BT's response to:

“Consultation and information on technical licence conditions for 800 MHz and 2.6 GHz spectrum and related matters”

Issued by Ofcom on 2 June 2011

Submitted to Ofcom on 10 August 2011

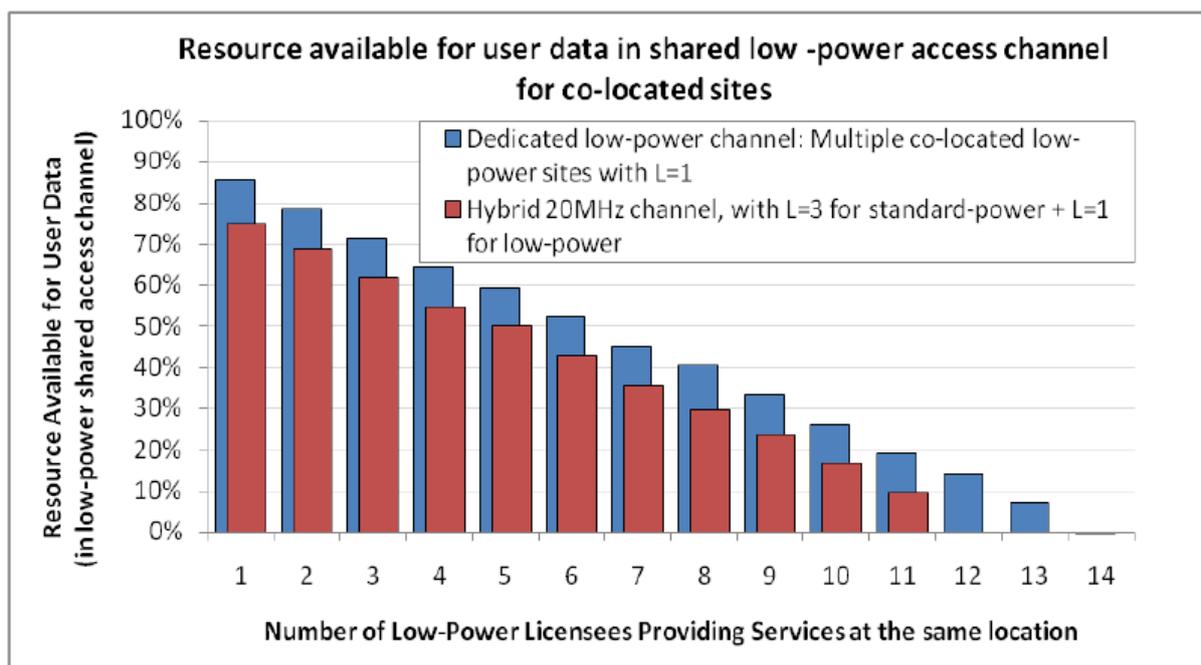
We are unclear as to why the proposed maximum antenna height of 12 m for outdoor deployment is necessary. It may also be difficult to clearly define what is indoor and what is outdoors in some situations, such as shopping centres. In the case of the TDD alternative out of block emission limit, we understand that the height restriction is to manage the TDD base station to FDD base station interference. However, in this instance where the low power FDD use is proposed to be located in the middle of the FDD band, we believe the 12 metre restriction is unwarranted and may constrain certain applications. Therefore, we propose that there should be no height restriction on low power FDD licences.
